Planning Permit Officer Report

PA2402895: 989-1009 Collins Street, DOCKLANDS

Key Information	Details
Application No.:	PA2402895
Received:	1 May 2024
Applicant:	Lendlease Development Pty Ltd, C/- Urbis Pty Ltd
Architects:	Kennon and Ewert Leaf
Planning Scheme:	Melbourne
Land Address:	989-1009 Collins Street, Docklands (CW4 Victoria Harbour Precinct)
Proposal:	Buildings and works associated with the construction of a residential tower (Collins Wharf 4), associated car parking and public realm works.
Total Site Area:	4,490sqm
Gross Floor Area:	49,857sqm
Floor Area Ratio:	11:1
Development Value:	\$199M
Built form:	29 storeys (97.35m AHD)
Tower Setbacks:	North : 11.8m, West : 6.485m, South: 11.23m, East: 4.0m
Dwellings:	349 dwellings 104 (30% 1 bed), 187 (53% 2 bed), 46 (13% 3 bed), 12 (4% 4 bed)
Parking:	223 Car parks 214 Bicycle and 4 Motorcycle
Zone:	Docklands Zone Schedule 2 (DZ2) Victoria Harbour Precinct Docklands Zone Schedule 7 (DZ7) Waterways
Overlays:	Development Plan Overlay Schedule 3 (DPO3) Victoria Harbour Precinct Design and Development Overlay Schedule 12 (DDO12) - Noise Attenuation Area Design and Development Overlay Schedule 50 (DDO50) Victoria Harbour Precinct, Area

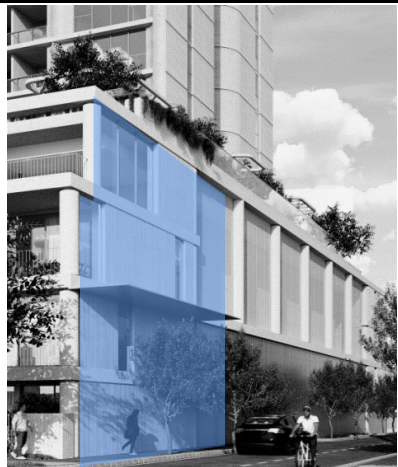
We recommend the integration of lighter-weight upper-level elements, such as steel fin balustrades to upper-level balconies, to instil a sense of domesticity to the upper levels. This will unify the design language of both the upper and lower forms of the building into one cohesive piece. We recommend finer grained elements are adopted to the lower component of CW4 (see right, highlighted in blue).

This issue was highlighted within pre-application discussions and within the RFI and remains outstanding.

Conditions of permit (included as part of Condition 1) will require a number of modifications to provide a response to the issues raised. The below conditions are considered to appease key urban design concerns and provide for a greater sense of activation along Dock Lane:

Figure 29: Dock Lane Interface

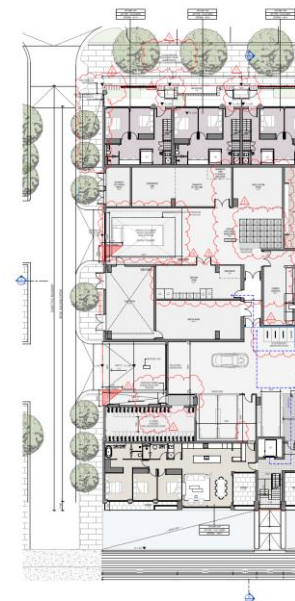
90. The podium levels of the development will however not have an appropriate active interface to Dock Lane. The western elevation of the development (podium levels) will be provided with perforated metal facades along, required to facilitate natural ventilation to the car park. Whilst this is accepted, this undermines the role of Dock Lane. The DP envisages this Lane, approximately 60 in length, as a shared zone rather than a service lane.

Figure 32: Wind mitigation on Community Green

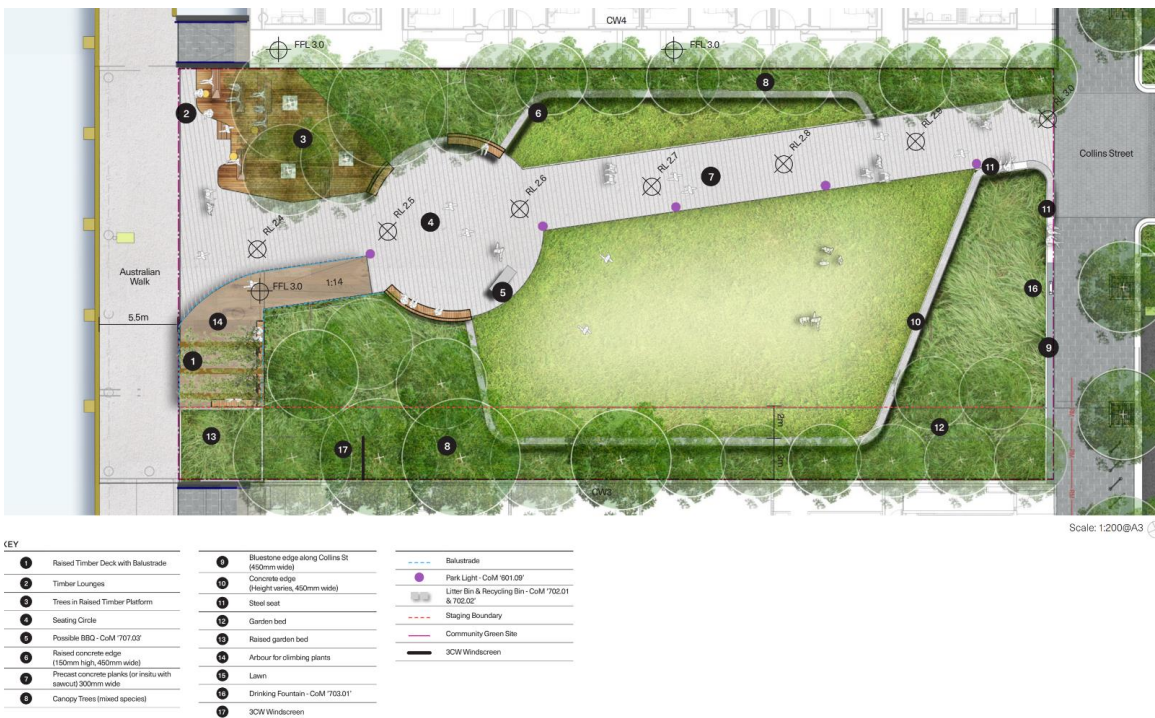
96. The wind report provides, as a mitigation measure, provision of a 3m porous screen on the Community Green (see Figure 32). This is not a preferred outcome. Further assessment is required for wind impacts on the Community Green and mitigation measures in consultation with Council to make this space usable for the purpose intended. Details of any screening will be required.
